## PRODUCT INFORMATION NOTIFICATION

**PIN:** PIN193803

**Subject:** Qualification of New Cover Tape (CPAK) for Tape and Reel Shipment at Cypress Philippines

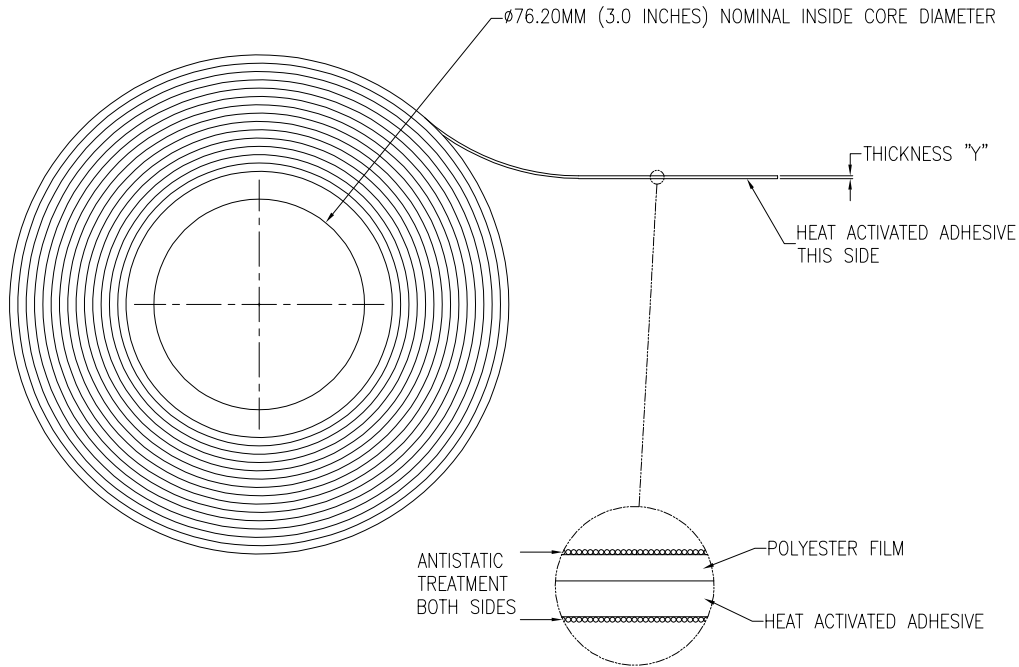
Cypress has qualified an EIA standard outline cover tape for all tape and reel shipment at Cypress Philippines (CML, Gateway Business Park, SEPZA, Brgy., Javalera, General Trias, Cavite, Philippines). The new cover tape meets the Cypress specification and demonstrates the same quality as the current cover tape.

Carrier Tape Width	Current Cover Tape		Newly Qualified Cover Tape		Remarks
	HUB Type	Color	CP38 Type	Color	
12 mm	9.2 mm	Transparent	9.2 mm	Natural	Same width dimension. Same in transparency during visual inspection
16 mm	13.3 mm		13.3 mm		
24 mm	21.0 mm		21.0 mm		
32 mm	25.5 mm		25.5 mm		
44 mm	37.5 mm		37.5 mm
